DECISION OF THE PLANNING ADMINISTRATOR

SUBDIVISION / CLASS 2 ADJUSTMENT CASE NO.: SUB-ADJ19-03

REQUEST: A tentative subdivision plan to divide approximately 9.63 acres into 48 lots ranging in size from 4,428 square feet to 11,492 square feet including Alternative Street Standards request to increase the street grade from 12% to 15% for five street intervals and 50-foot right-of-way, where 60-feet is required; and a zoning adjustment to re-designate the front property lines for Lots 8, 19, 34, 43 and 44.

**BEFORE THE PLANNING ADMINISTRATOR
OF THE CITY OF SALEM
(SUBDIVISION PLAT NO. 19-03)**

TENTATIVE SUBDIVISION PLAN

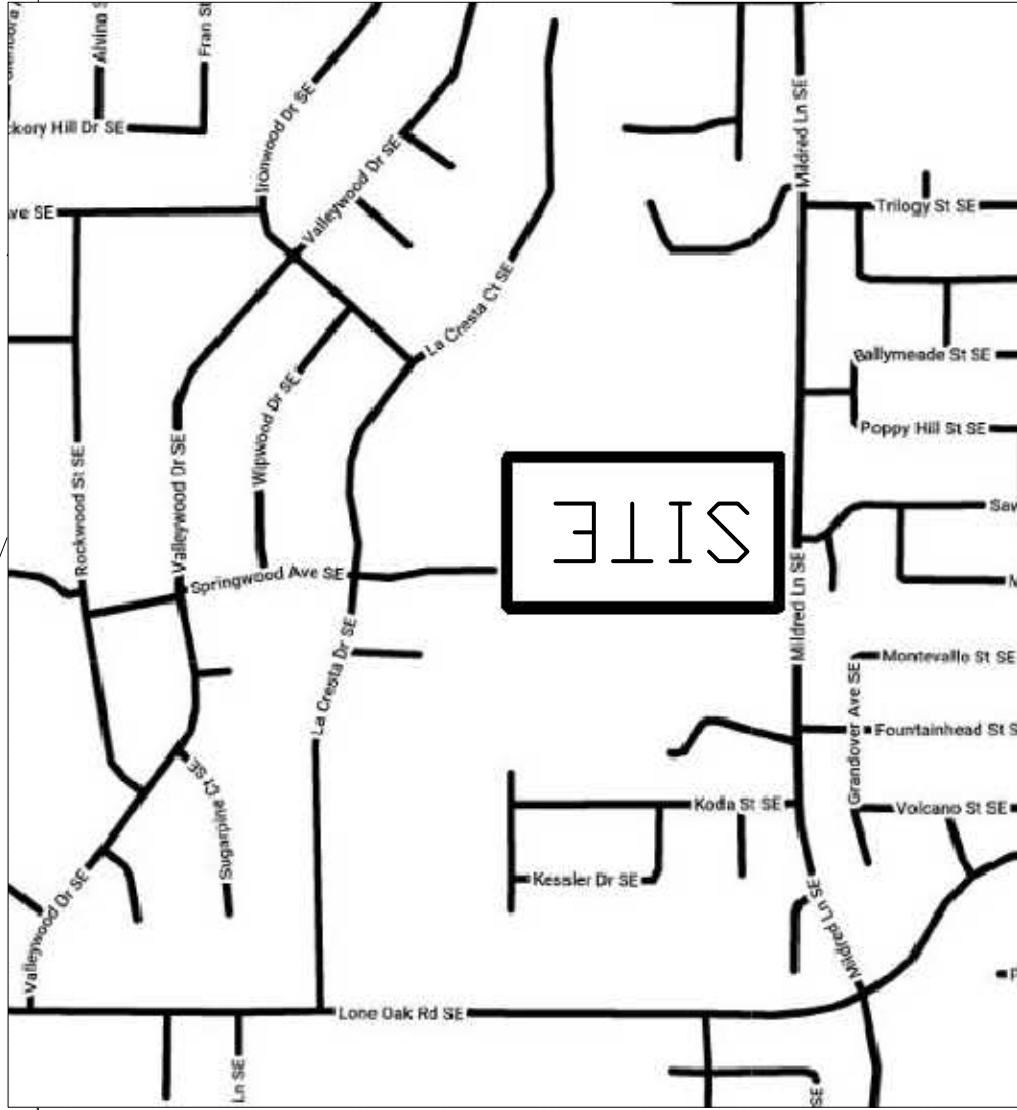
As shown on the applicant's tentative subdivision plan, the proposed lots, with exception of the proposed flag lots (Lots 5, 6, and 7), exceed the minimum 40-foot street frontage requirement. Proposed Lots 5, 6, and 7 are flag lots without the minimum frontage on a street. These proposed lots conform to the flag lot standards of SRC 800.025.

SRC 800.025 (Flag Lots): Proposed Lots 5, 6, and 7 are flag lots. Subsections (a) and (b) specify that minimum lot area and dimensions for a flag lot shall be calculated exclusively of the flag lot accessway. All proposed flag lots exceed the minimum lot area and dimensions exclusive of the flag lot accessway. The applicant is requesting an adjustment to change the front property line of Lot 8 to the west property line (easement line), which would allow access to all four lots. In addition the applicant is requesting an adjustment to designate the south line for Lot 19 as the south. Lot 19 has adequate frontage and is not considered a flag lot.

The tentative plan shows an easement width of at least 25-feet wide, however, plans do not indicated the paved width of each accessway. To ensure this standard is met, the following condition shall apply:

Pursuant to subsection (c), street grade for of a local street shall not exceed 12 percent. The applicant has provide street profiles and a written statement that all streets have been designed not to exceed 12 percent meeting this standard. The applicant does not need an alternative street standard for increased grade.

As shown on the Tentative Subdivision Site Plan, prepared by Willamette Engineering, Inc., East Street is planned as a north-south street serving a portion of the eastern half of the property. The other streets in the subdivision are Springwood Avenue, running north-south through the entire western half of the property; and South Street, running east-west across the south part of the property. Both of these streets, and two others extending to the west and east lines, will be 60' right of way.

Condition 3: Prior to Final Plat approval, the flag lot accessway serving Lots 5 through 8 shall be paved in accordance with the requirements of SRC 800.025(c), Table 800-1, for a residential flag lot accessway serving 3 to 4 lots.

Condition 7: Construct internal streets to local street standards pursuant to PEDS except as authorized through a Design Exception by the City Engineer. The alternative street standard for East Street shall be constructed as proposed, with 50-foot right-of-way, four foot landscaping strip and property line sidewalks.

EAST STREET GRADING PLAN (PRELIMINARY)

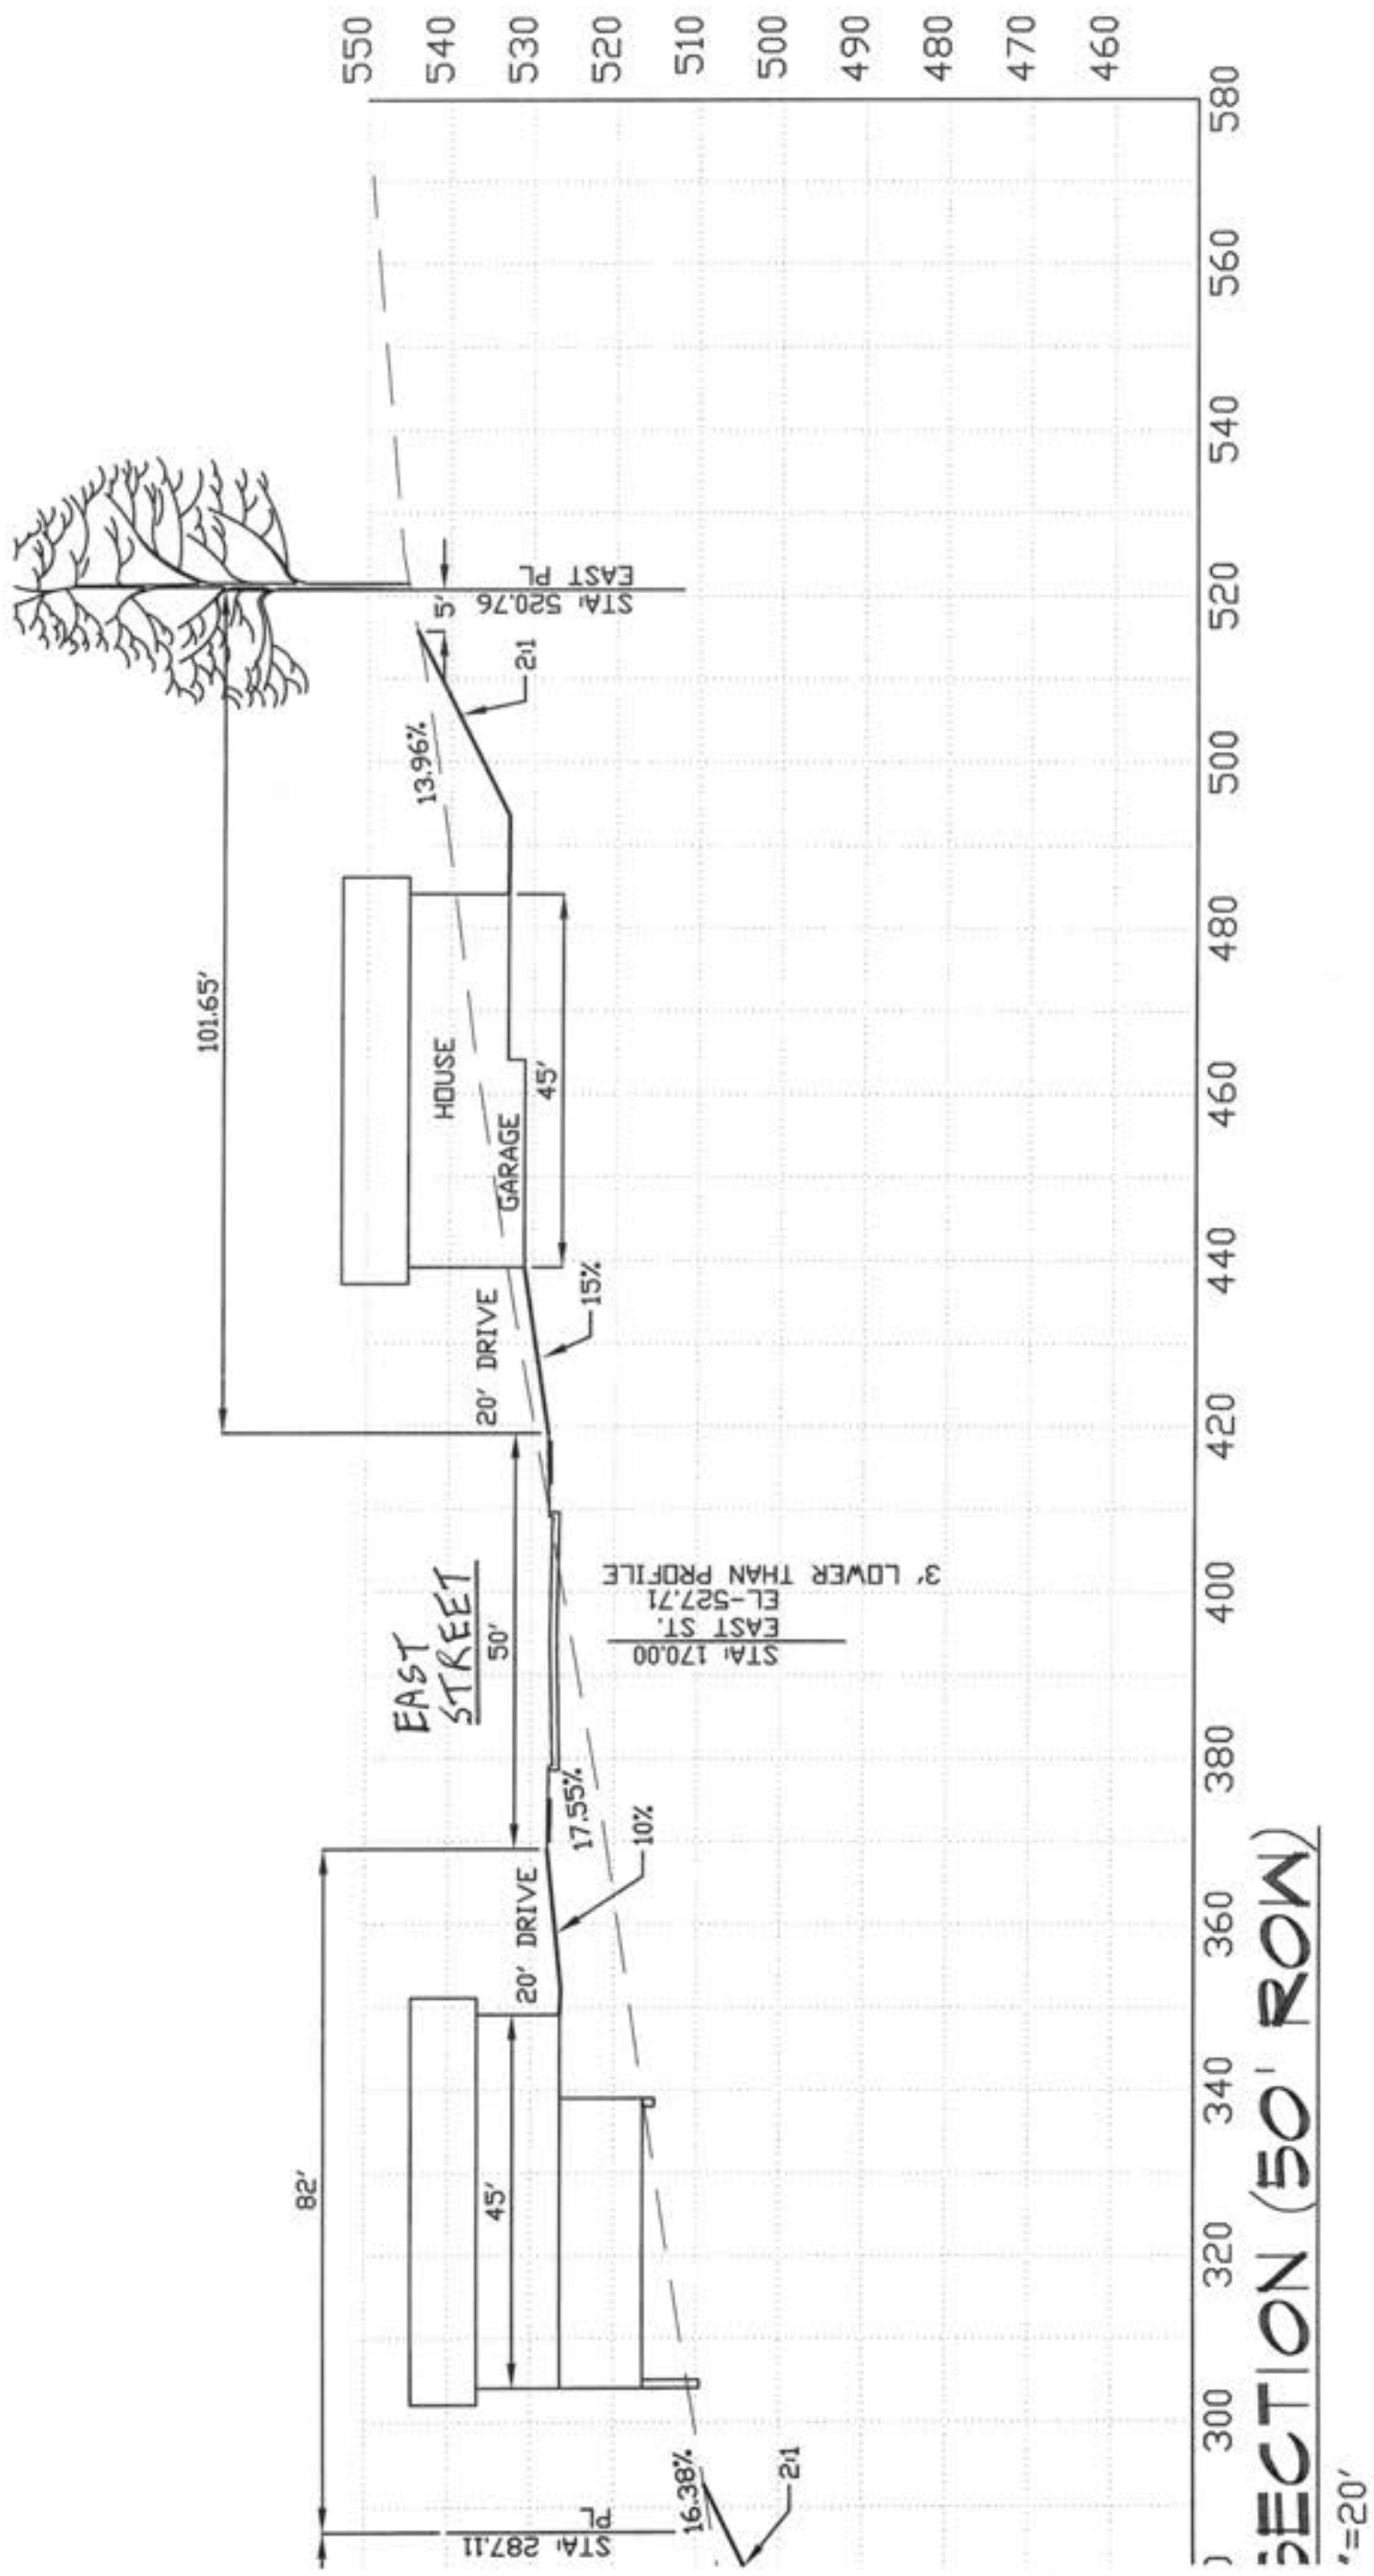
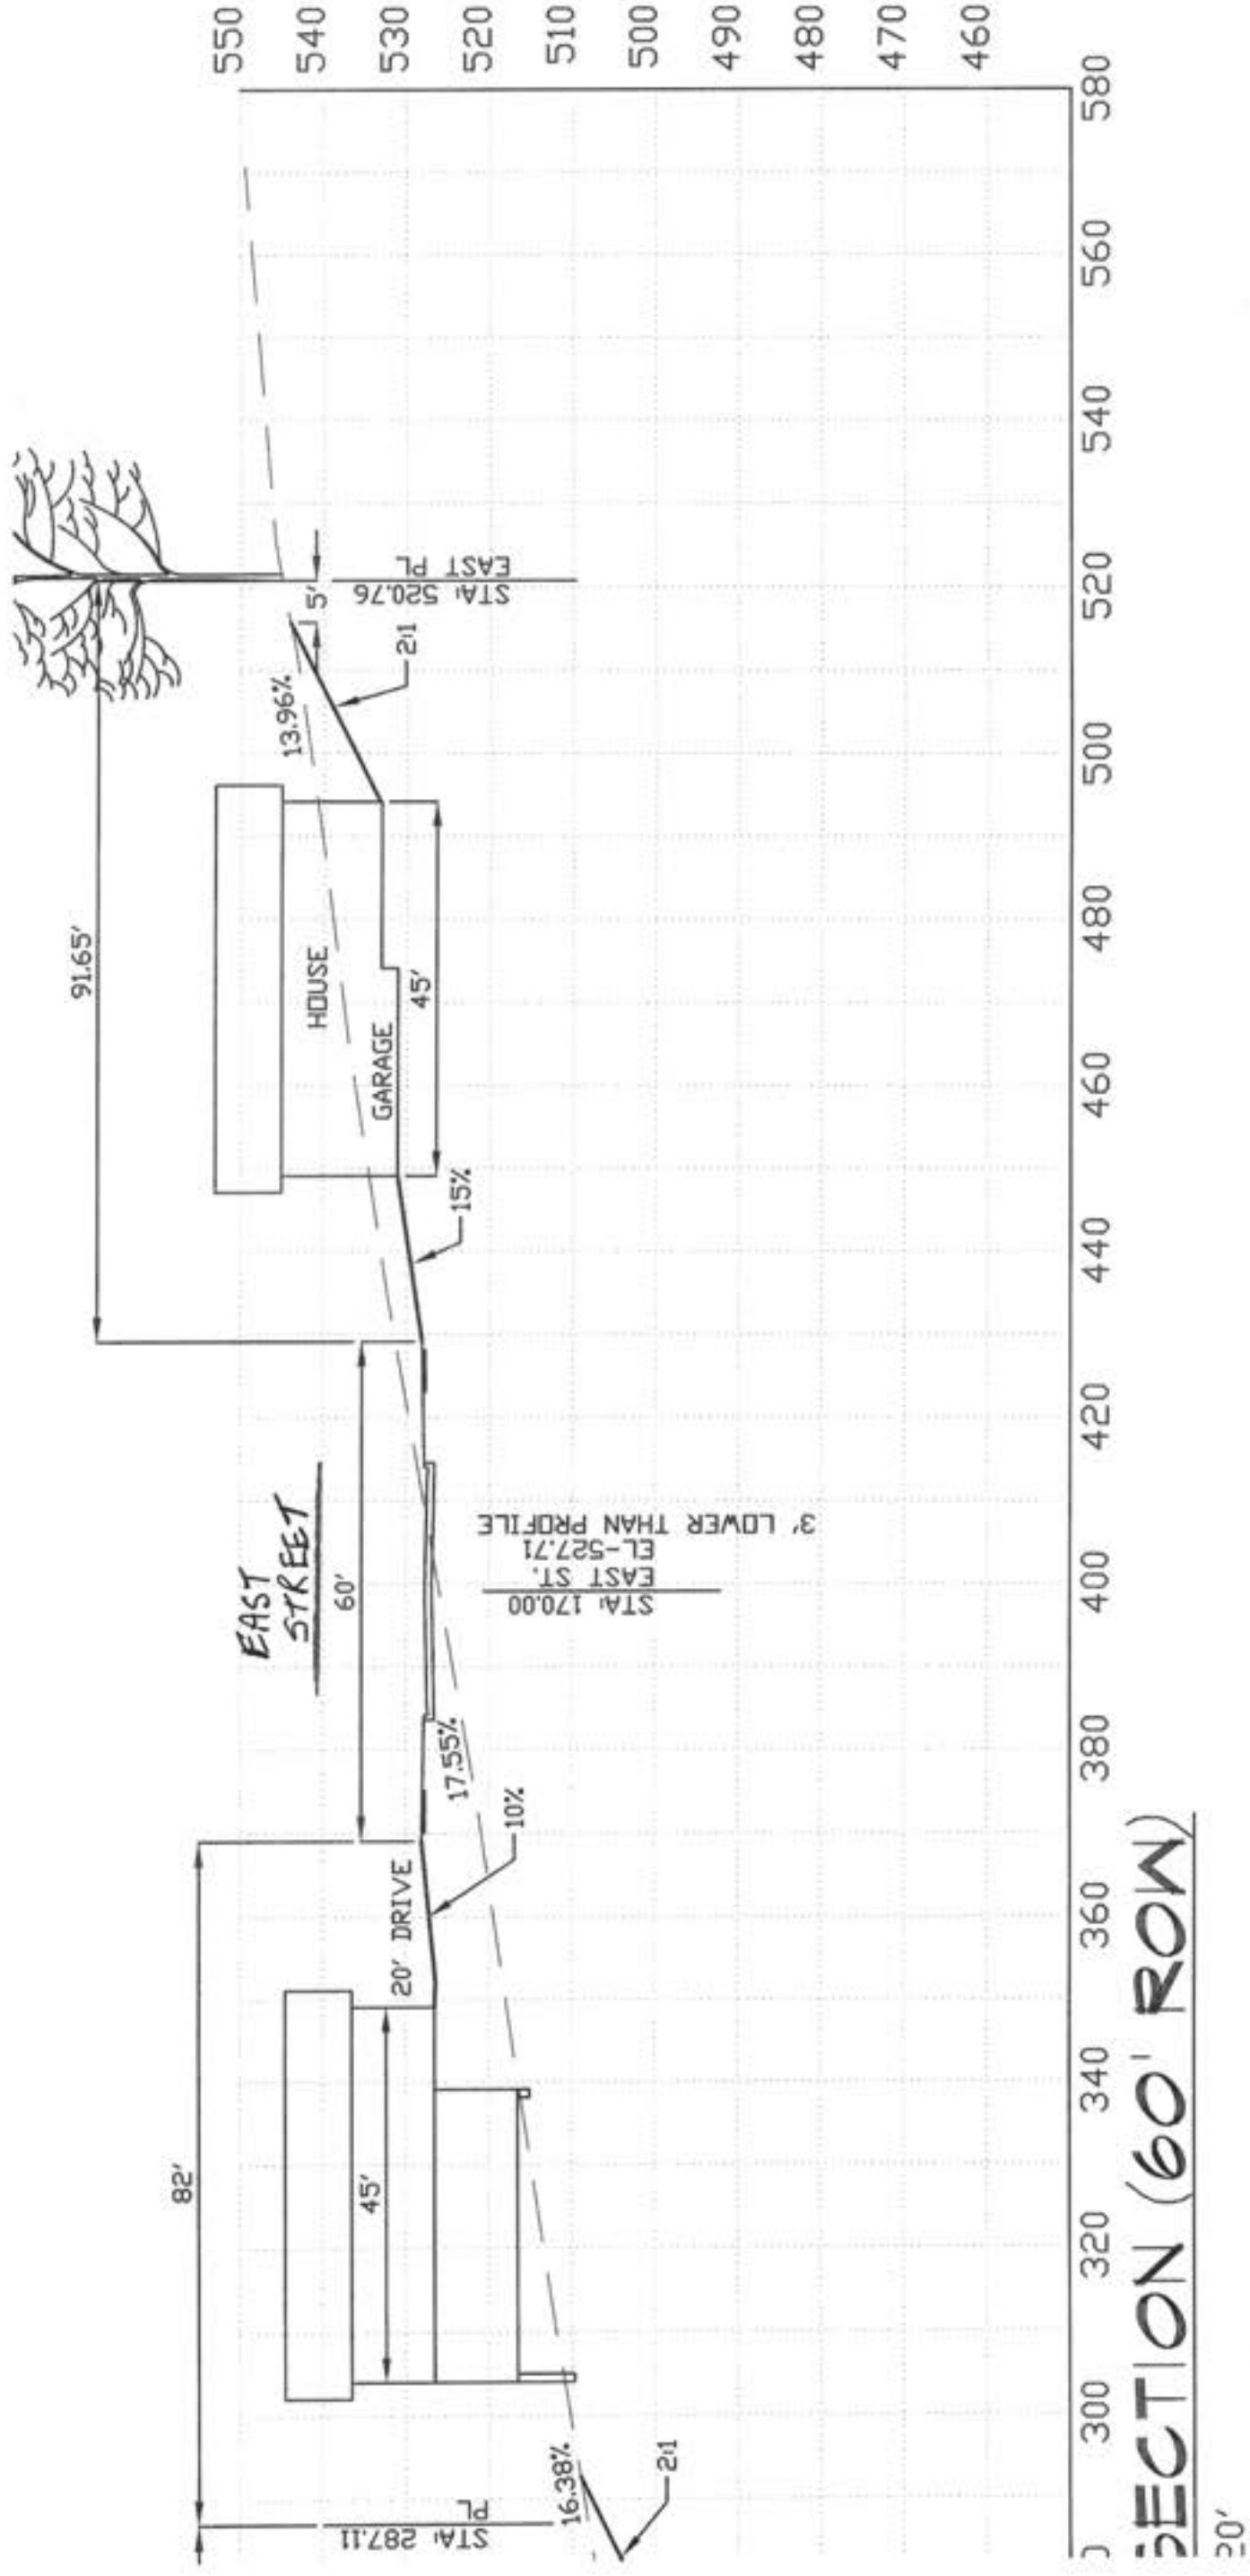
1. The Easterly neighbor, Arlie Mummy, has expressed mutual concern with the Developer concerning the east tree line. His concern would addressed by increasing Lots 9 through 15 to 101'. This provides adequate separation between the trees and beginning of the site grading. His letter is attached at the end of this narrative. The Arlie Mummy letter is attached at end of this narrative.
2. Preliminary Grading Plan along East Street – this plan presents the building pads resulting with a 101' lot depth. The grading begins a distance from the east line to preserve tree line root zones. If the lot is decreased by 10' the building envelope and backyard (items for quality living) would be reduced accordingly. The Preliminary Grading Plan is attached at end of this narrative.

- 1) Is it safe to cut the proposed bank for necessary grade change along the east side of the property, can this be done without undermining the structural integrity of the existing, established row of trees on the neighboring property adjacent to the work site?
- 2) Are there trees suitable for growth within the planned 5' planter strip?

- a) The row of trees in question does seem to be potentially within striking distance of proposed new homes as well as property of the neighbor on whose land the trees are located.
- b) It is my opinion the planned bank CAN be created without threatening the trees ability to remain standing and in good health. It may be advisable to have a certified Arborist on site to observe the portion of any excavating and operation of heavy equipment taking place near and in the critical root zone.
- c) To help minimize unnecessary damage during the excavation in the sensitive areas where roots are present. I recommend use of a 50' right of way, thereby creating deeper lots (affecting lots 6-16) and allowing more room, helping prevent digging too near any structurally strategic roots.

In conclusion, it is my expert opinion as an ISA certified Arborist that creating the proposed necessary bank as illustrated in the site drawings will have no adverse effect on the lifespan of the existing row of trees in question here and will not limit their lifespan or lessen their structural integrity. In addition, requesting the 50' right of way creating deeper lots allowing additional back yard space and added room for the bank to occupy further from the root zone.

Condition 8: Prior to Public Construction, the applicant shall have a certified arborist prepare a tree preservation and protection plan for Lots 5 through 16. The plan shall provide the trees size, location, species, extent of root cover, an evaluation of the trees tolerance to construction, and what is an adequate level of protection for the trees based on the findings from the site visit.

Condition 10: Prior to Public Construction, the applicant shall have the certified arborist, who prepared the protection plan, mark the root protection zone with fencing and root protection zone signage indicating no ground disturbance activity for Lots 5 through 16.
